BOARD ACTION REPORT – APPEALABLE ITEM

Project Name: 32 East Atlantic Avenue
Project Location: 32 East Atlantic Avenue, Old School Square Historic District
Request: Class III Site Plan Modification and Certificate of Appropriateness
Board: Historic Preservation Board
Meeting Date: March 7, 2018

STAFF REPORT

ITEM: 32 East Atlantic Avenue, Old School Square Historic Arts District – Class III Site Plan Modification and Certificate of Appropriateness (2018-004) for alterations to the front façade (North), and installation of a 160 square foot, outdoor, walk-in cooler.

PROPOSED SITE PLAN

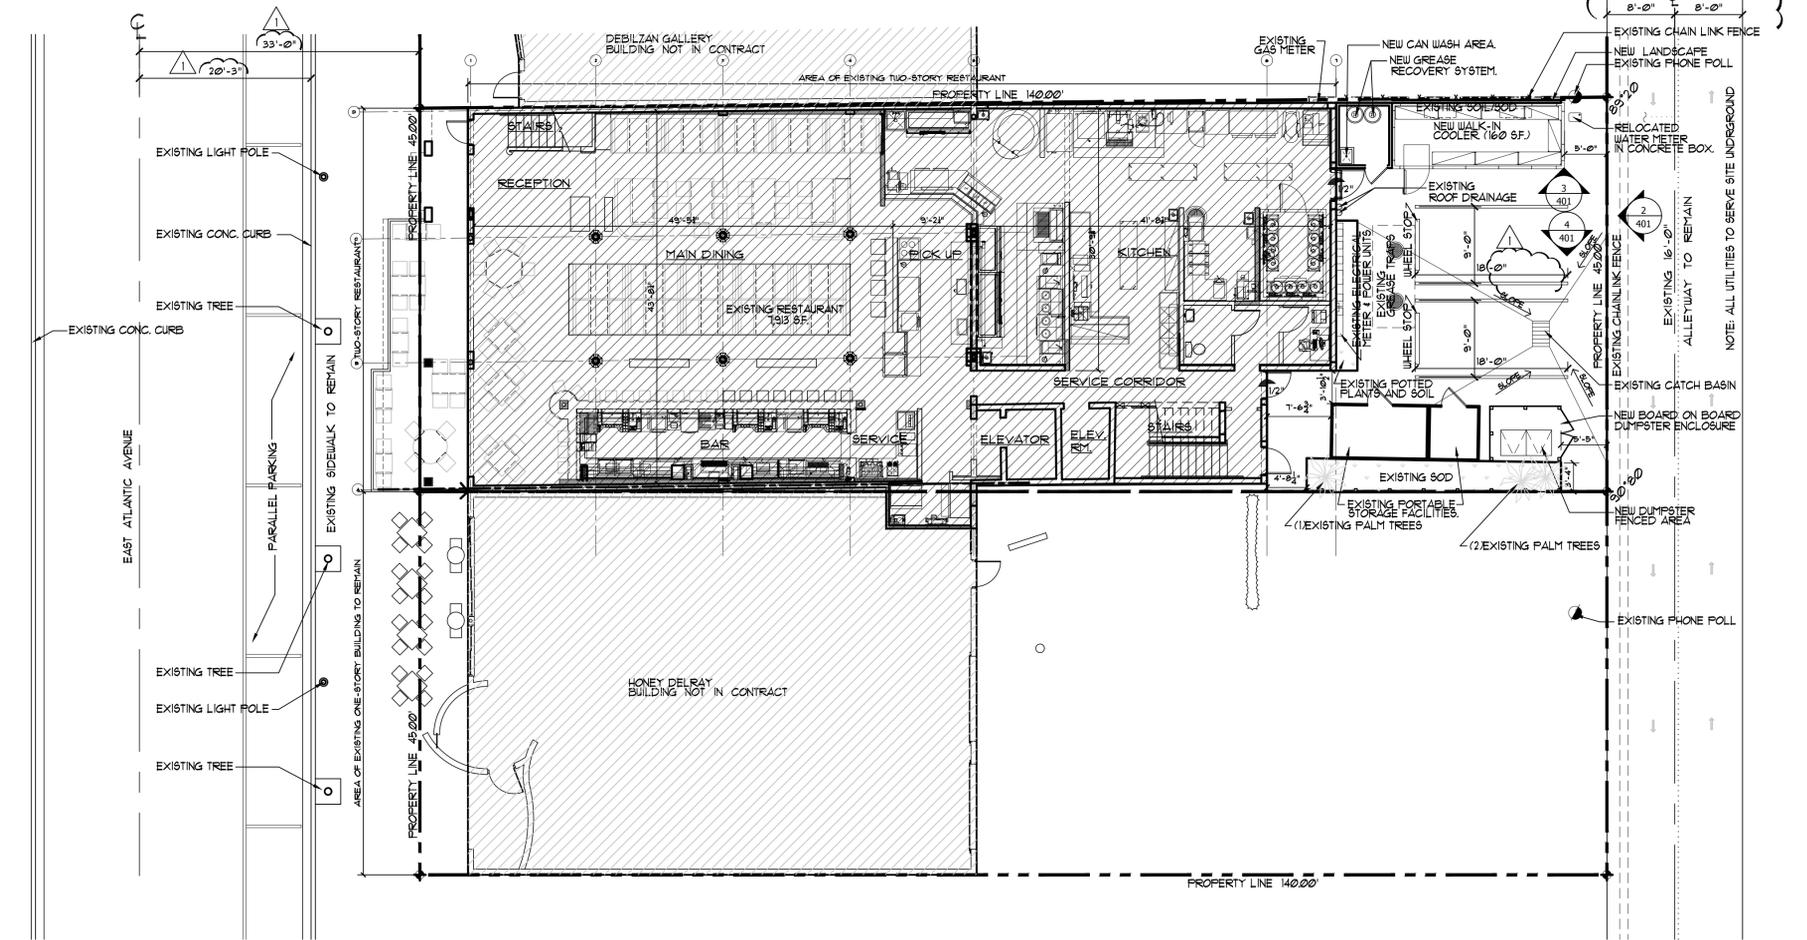
1. In the site data table, on sheet A101, reorganize table to include columns for required, existing, and proposed setback, height, open space, pervious/impervious, etc.
2. In the site data table, on sheet A101, revise the land use designation to OMU (Other Mixed Use).
3. Provide height dimension of the screening of mechanical equipment on top of walk-in cooler on elevation drawings.
4. Submit a revised NOA for the Nana Wall System to correlate with the elevation drawings.

1. In the site data table, on sheet A101, reorganize table to include columns for required, existing, and proposed setback, height, open space, pervious/impervious, etc.
2. In the site data table, on sheet A101, revise the land use designation to OMU (Other Mixed Use).
3. Provide height dimension of the screening of mechanical equipment on top of walk-in cooler on elevation drawings.
4. Submit a revised NOA for the Nana Wall System to correlate with the elevation drawings.

1 NORTH ELEVATION
 SCALE: 1/4" = 1'-0"

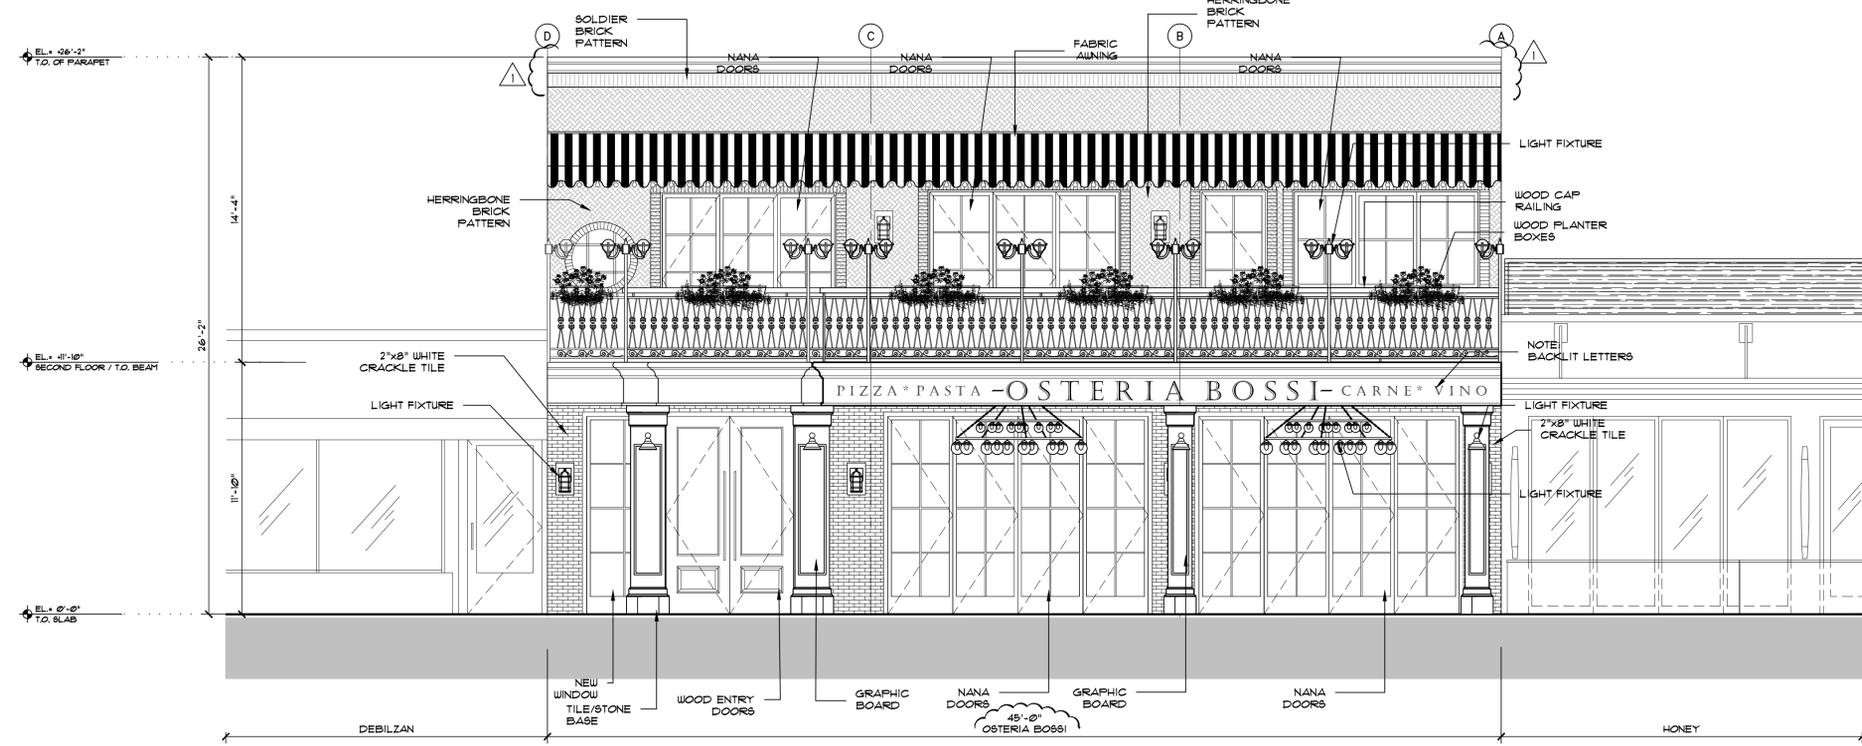
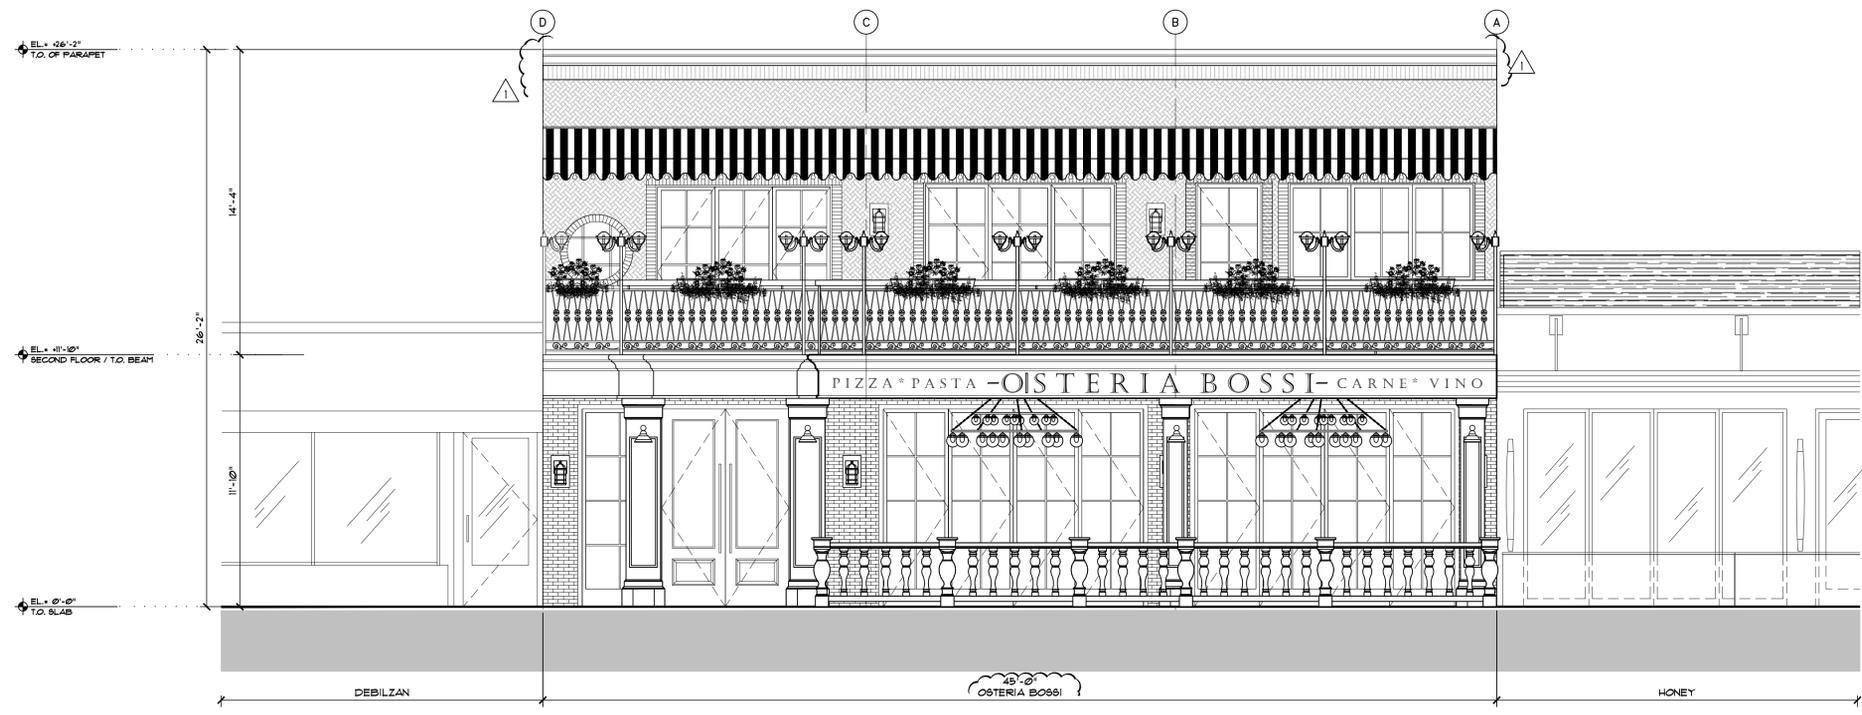
The alterations to the front façade include new nana doors (bi-fold glass wall door systems), wood entry door with glass panels and sidelights, new exterior light fixtures, white cracked tile on the first floor, herringbone brick pattern on the second floor, wood planter boxes along the second floor railing, architectural crown feature at the top of building with soldier brick pattern below, awning, and railing. The exterior color scheme will be changed to Benjamin Moore "Black Ink" moldings, Benjamin Moore "Incense Stick" railing, and Benjamin Moore "Avon green" planter boxes. The spaces that characterize the property are being preserved by maintaining outdoor seating on the

the front façade will modify the existing proportion of openings. On the first floor, nana doors (bi-fold glass wall door systems) are being proposed which require larger openings than the existing windows and doors. A wood entry door with glass panels and sidelights on the left side of the door are also being proposed. On the second floor, nana doors are proposed in a different configuration than existing windows and doors. In addition, a new round window is used on the left side of the second floor. These changes are visually compatible to other restaurants on East Atlantic Avenue that maximize visibility with large windows and glass panel doors. The alterations to the front façade include white cracked tile on the first floor, herringbone brick pattern of the second floor, wood planter boxes along the second floor railing, architectural crown feature at the top of building with soldier brick pattern below, exterior light fixtures, awning, and railing. The paint pattern will include Benjamin Moore "Black Ink" moldings, Benjamin Moore "Incense Stick" railing, and Benjamin Moore "Avon green" planter boxes. The relationship of the materials, texture, and color contribute to the "Old Delray Beach" feeling and atmosphere of the Old School Square Historic Arts District (OSSHAD). The proposal creates a cohesive design by introducing elements from only one architectural style.
